ADDENDUM NO. 3

1904 / KVCC WHITNEY WING RENOVATIONS

Lewis + Malm Architecture

30JAN2020

KVCC WHITNEY WING RENOVATION
 FAIRFIELD, MAINE
 FIRE ALARM
 LAYOUT PLAN

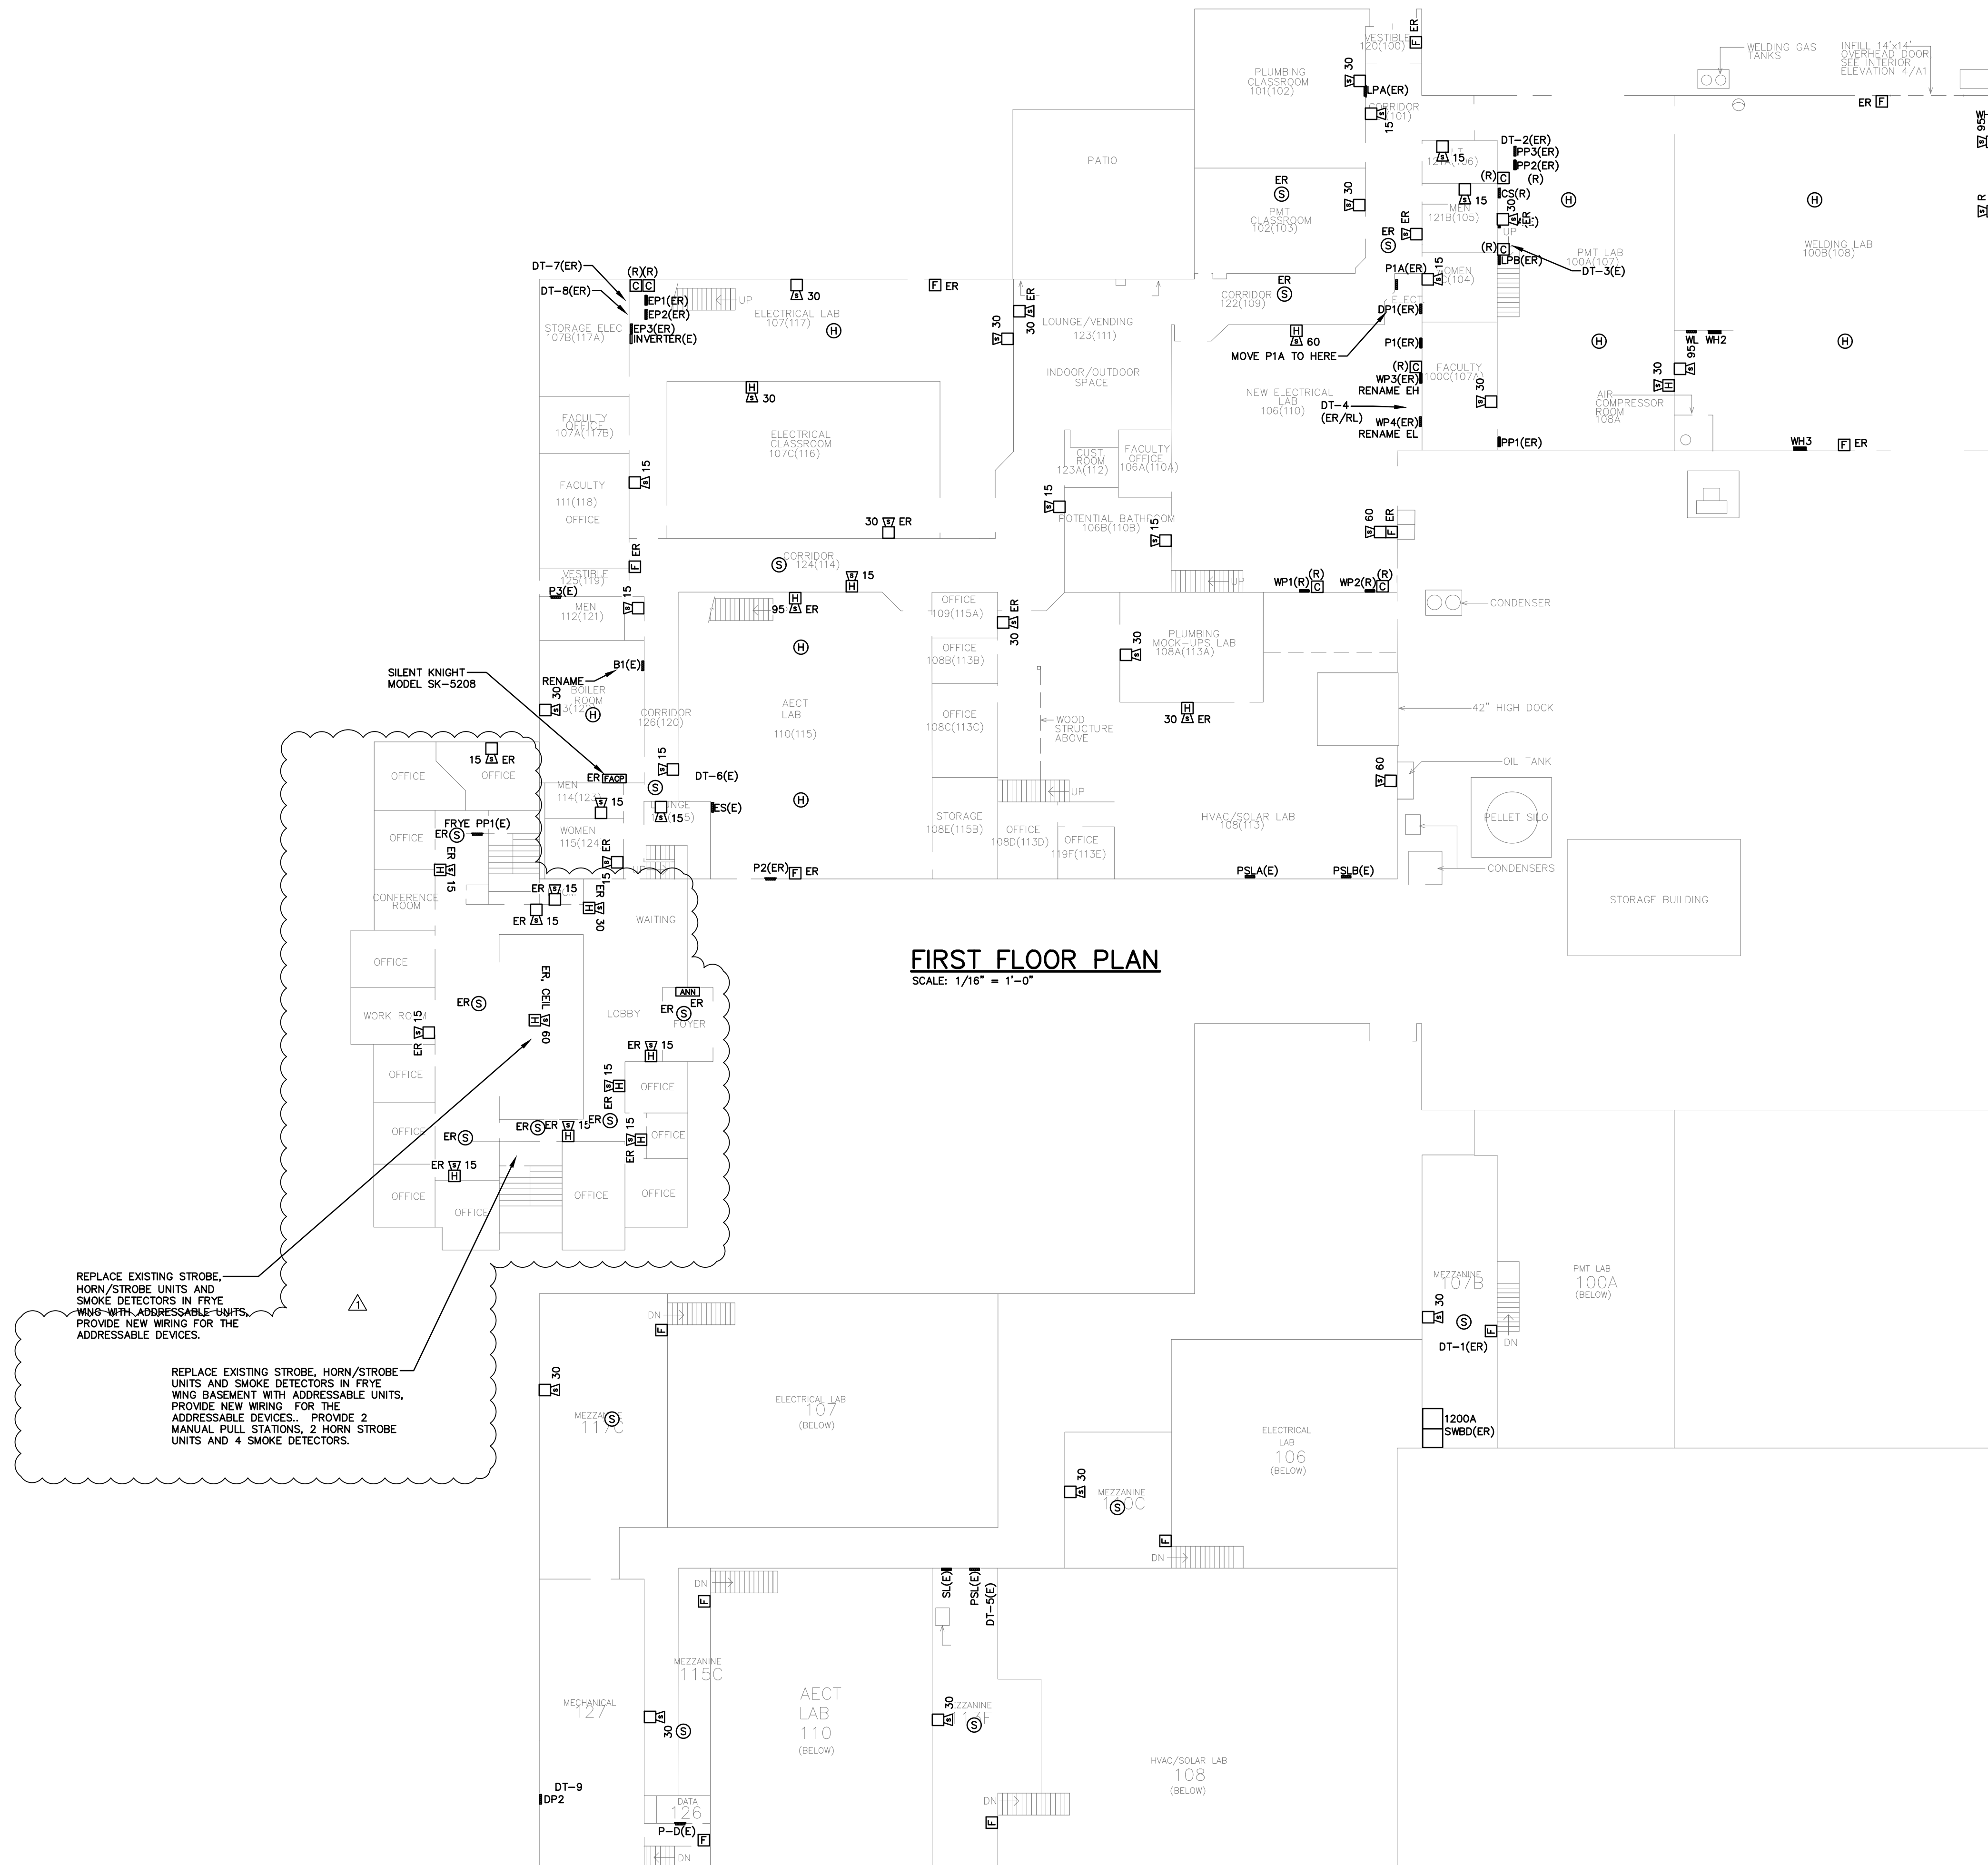
QUESTION 1) Please clarify the general note (at lower left corner of Drawing E3) regarding replacement of all existing FA signaling devices to addressable type, in the Frye Building. Only a handful of FA devices are depicted on the drawing within the Frye Building area, whereas this note potentially implies that many more FA devices than shown on the drawing within the Frye Building may require removal and replacement.

RESPONSE TO Q1: More devices are now shown (see drawing E3). Additionally, a note was added to include 2 manual pull stations, 2 horn/strobe units and 4 smoke detectors in the basement of Frye.
